MARUCCI ENGINEERING ASSOCIATES, LLC

February 13, 2026

Re: 223-225 North 16th Street
Map 3 Block 19 Lots 36 & 38
Neyda Feliciano (owner/applicant)
Zone: R-2B, Two Family Residence District

National Flood Hazard Layer FIRMette

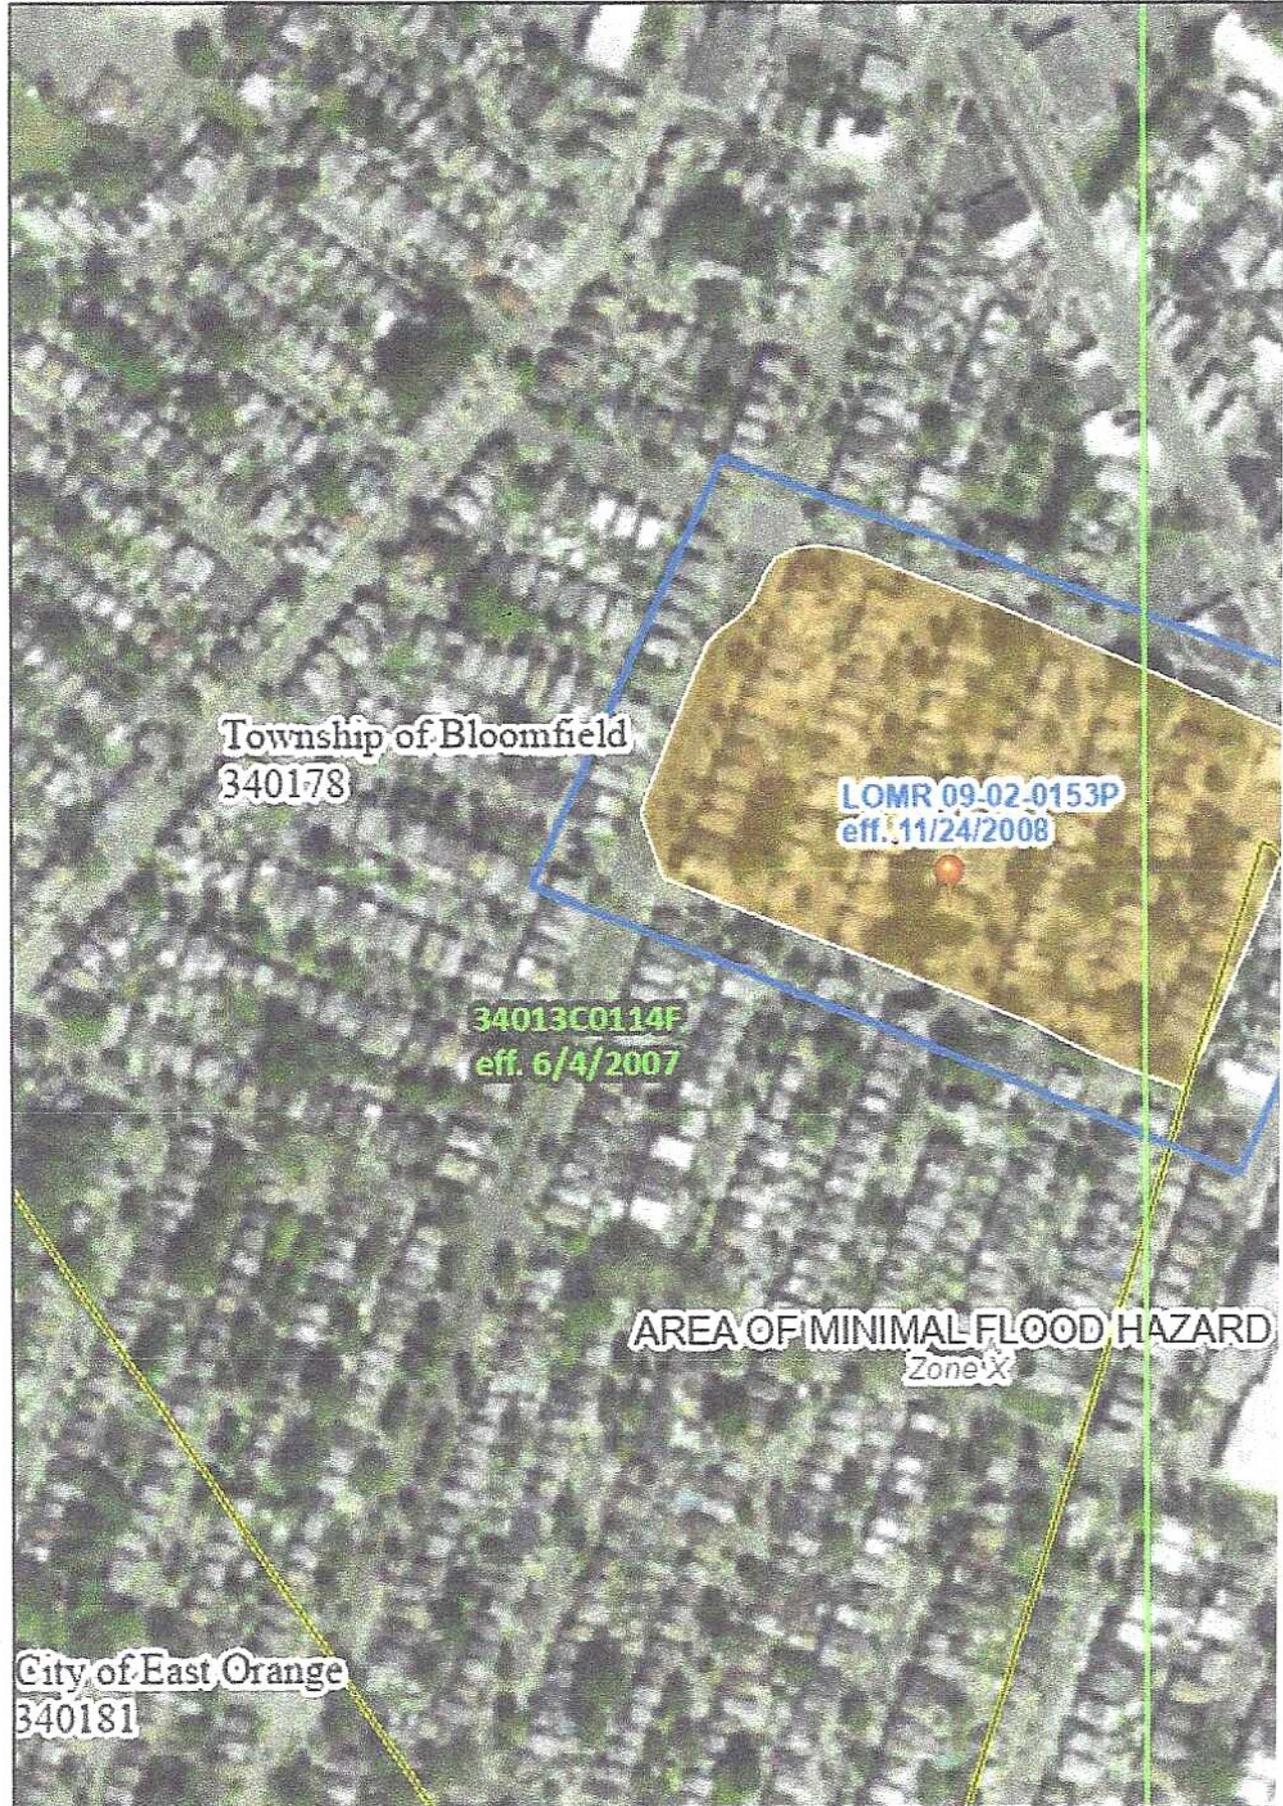
- This portion of North 16th Street is located in a FEMA Regulated Flood Hazard Area.
[See attached FIRM map]
Should the Zoning Board act favorably on this application, a Flood Hazard Permit shall be obtained from the NJ Department of Environmental Protection [NJDEP] prior to the submission and approval of construction permits for the new single family dwelling.
- Should NJDEP approve the Flood Hazard Area permit, a grading & drainage plan with stormwater management shall be designed for the new dwelling by a Professional Engineer, licensed in the State of New Jersey, and submitted for review and approval by my office.
- As a condition of Zoning Board approval, the sidewalks along the proposed dwelling frontage as well as the frontage along #225 North 16th Street shall be reconstructed as directed and approved by the Township Engineer's Office.
